SUBJECT: NuScale Power, LLC Supplemental Response to NRC Request for Additional Information No. 201 (eRAI No. 8975) on the NuScale Design Certification Application

NuScale Supplemental Response to NRC Request for Additional Information eRAI No. 8975

NRC Question No.: 03.08.04-26

Figure 3B-15: RXB Reinforcement Elevation at Grid Line 4 Wall

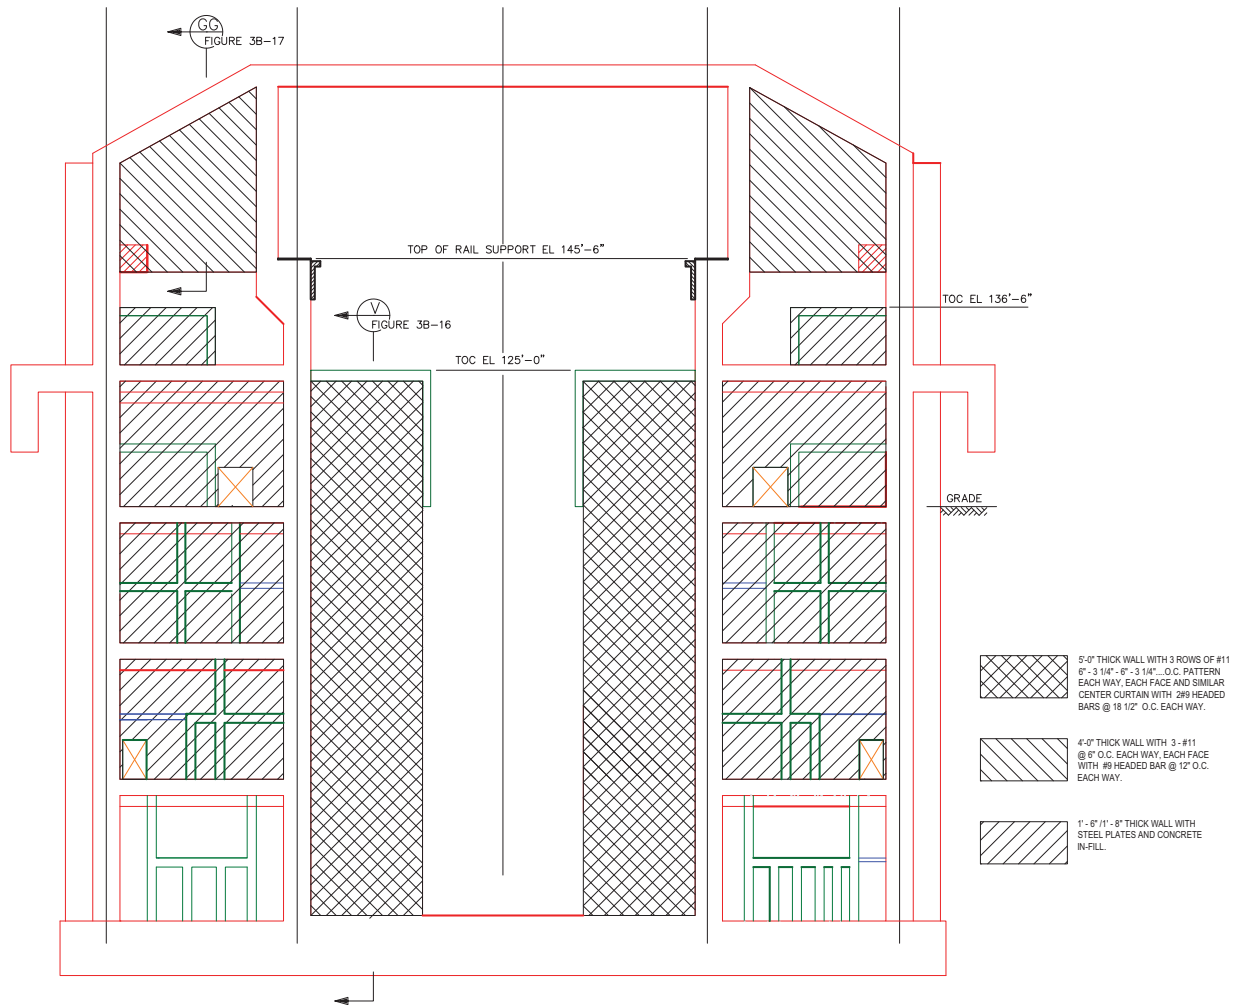
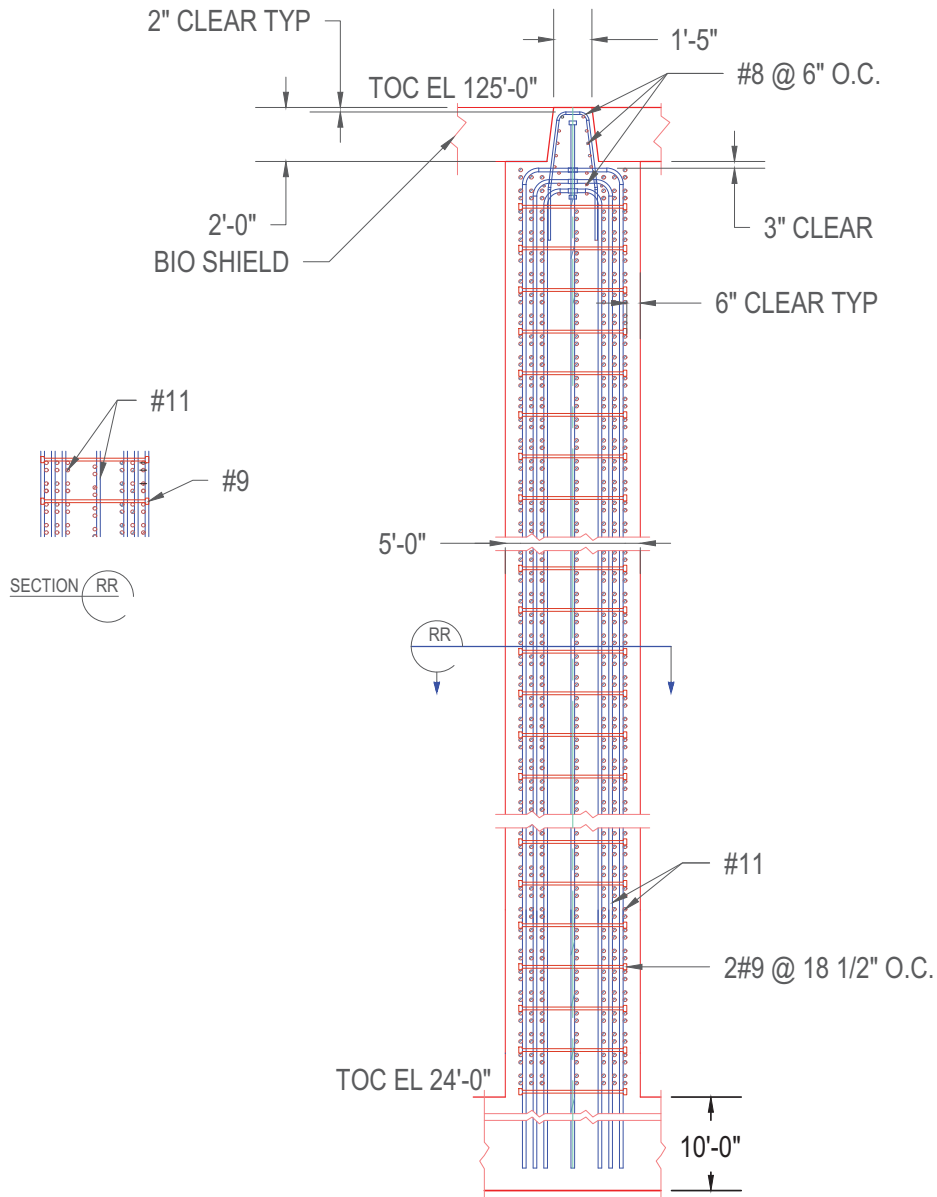
FSAR Tier 2, Appendix 3B, 3B.1.1.1, 3B.1.1.2 & 3B.2.7.1, and FSAR Tier 2, Tables 3B-4, 3B-5, 3B-6, 3B-9, 3B-12, 3B-22, 3B-45, 3B-55 & 3B-66 through 3B-94, and FSAR Tier 2, Figures 3B-15 & 3B-16 have been revised as described in the response above and as shown in the markup provided in this response.

Reinforcement drawings and section details are presented in ~~Figure 3B-43 and Figure 3B-44~~ [Figure 3B-15 and Figure 3B-16.](#)

Beams	Beam at EL. 75'-0"	3B-38, 3B-39	2'-0"
Buttresses	Buttress at EL. 126'-0"	3B-41	5'-0"
NPM Bay	West wing wall	3B-43, 3B-44 <u>3B-15, 3B-16</u>	5'-0"
	Pool wall	3B-46, 3B-47	5'-0"
